**TOWN OF ERIE
PLANNING COMMISSION MEETING
Wednesday, August 15, 2018**

SUBJECT: **PUBLIC HEARING:**
Resolution P18-11: A Resolution Making Certain Findings Of Fact And Conclusions Favorable To The Site Plan For Erie Commons Filing No. 4, 3rd Amendment, Town Of Erie, County Of Weld, State Of Colorado.

PURPOSE: Century Communities requests Site Plan approval to construct 77 single-family attached townhome dwellings units in Erie Commons Filing No. 4, 3rd Amendment.

Proposed Site Plan

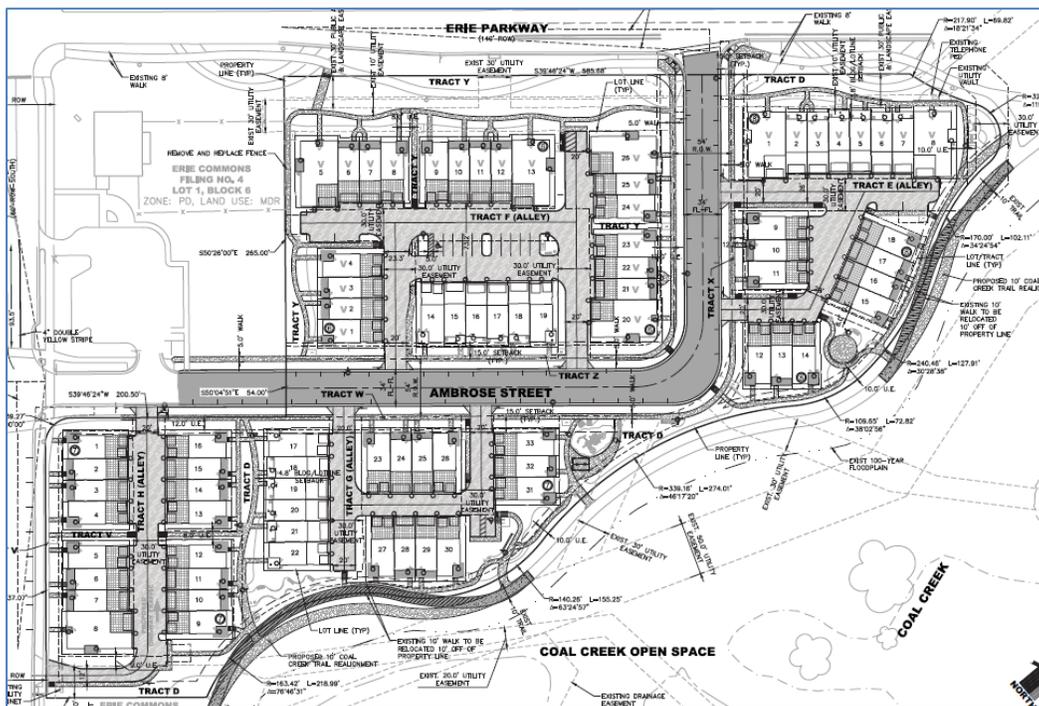
One building contains 8 townhome dwelling units, Lots 1-8, Block 8; exceeding the maximum number of dwelling units by 2 units. Only 1 building out of the 18 proposed buildings exceeds the maximum allowance. The applicant's justification for the request is that the building has been carefully designed in terms of orientation, building massing, architectural character and materials. The building is oriented towards Erie Parkway with front doors, stoops and porches creating a welcoming entry into Old Town. The two end units are one-story ranch plans which step down in scale and massing from two story to one-story units. A series of traditional farmhouse style gable end roof forms, in a variety of sizes, front onto Erie Parkway. Materials reflect the authentic farmhouse style with lap siding, paired porch columns, and stone base accents. The end units are also accessible and provide all the living spaces on the ground floor.

The 8-plex building was not shown in the Sketch Plan. In that plan, this area had two buildings with 4 units each. A 7-plex building was shown fronting Erie Parkway on the west portion of the site. The Town Board of Trustees commented that the 7-plex concept was not appropriate along the major thoroughfare. The Town has not previously approved a townhome building that exceeds the 6 unit maximum. Staff supports the Municipal Code 6 unit maximum standard.

One building containing 8 townhome units, Lots 1-8, Block 8, is 190 feet long; exceeding the maximum building length by 34'. Only 1 building out of the 18 proposed buildings exceeds the maximum building length. The applicant's justification for the request is that the proposed design provides ranch style end units that create a transition from the taller internal units to adjacent open spaces and street frontages. The alternative would be to split the structure into two 4-plex buildings, and replace the end units with typical two story end units. The applicant stated this would be a less desirable design solution lacking the transition in massing and product diversity.

As stated above, the Town has not previously approved a townhome building for more than 6 units in a row. The proposed 8 unit townhome building is 34' longer than the 156' length allowed by the Municipal Code. The Boulder Creek development in Erie Commons Filing 4 was approved with a building

Backing out exhibit with traffic engineer concerns shown in red.

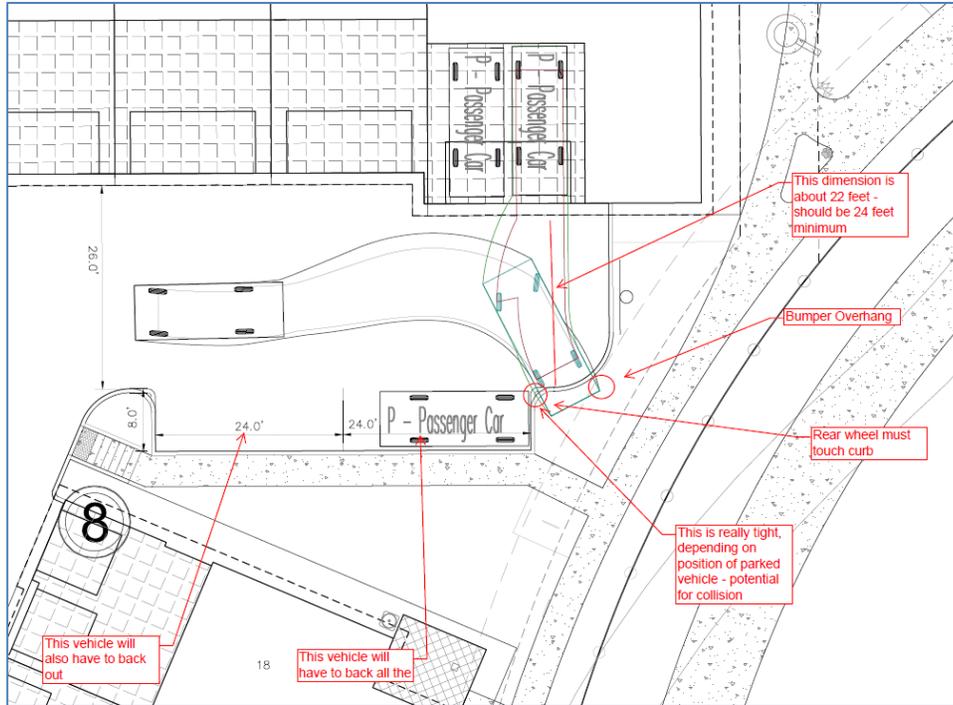
- Staff has also expressed concern over the alley in Tract E, more specifically, with the alley length, location next to the spine trail, backing movements from Unit 8, Block 8, and with snow removal in the alley.

Staff feels the applicant has adequately addressed most of the concerns except for the backing out of garage movements associated with Unit 8, Block 8. The backing out diagram provided by the applicant was reviewed and redlined by the Town's transportation engineer consultant illustrating potential conflict points. This garage is in the 8-unit townhome building that exceeds the maximum number of units by 2 units and length by 34 feet. Staff recommends bringing this building into conformance with Municipal Code which would shorten the building, allow for adequate alley length and more room for backing out of the garage. It would also result in safely fitting guest parking, alley right-of-way, snow removal, a fire hydrant, a no parking sign, screen fencing and the spine trail connection.

The applicant has addressed some of these concerns by incorporating screen fences to the east of the alley to block car headlights from shining on the spine trail. The applicant has provided turning and backing exhibits for Unit 8, Block 8 showing how a vehicle can exit the garage. Also, the snow storage area has been designed and graded to drain back into the alley and into the storm sewer versus draining onto the spine trail and potentially icing over in the winter.
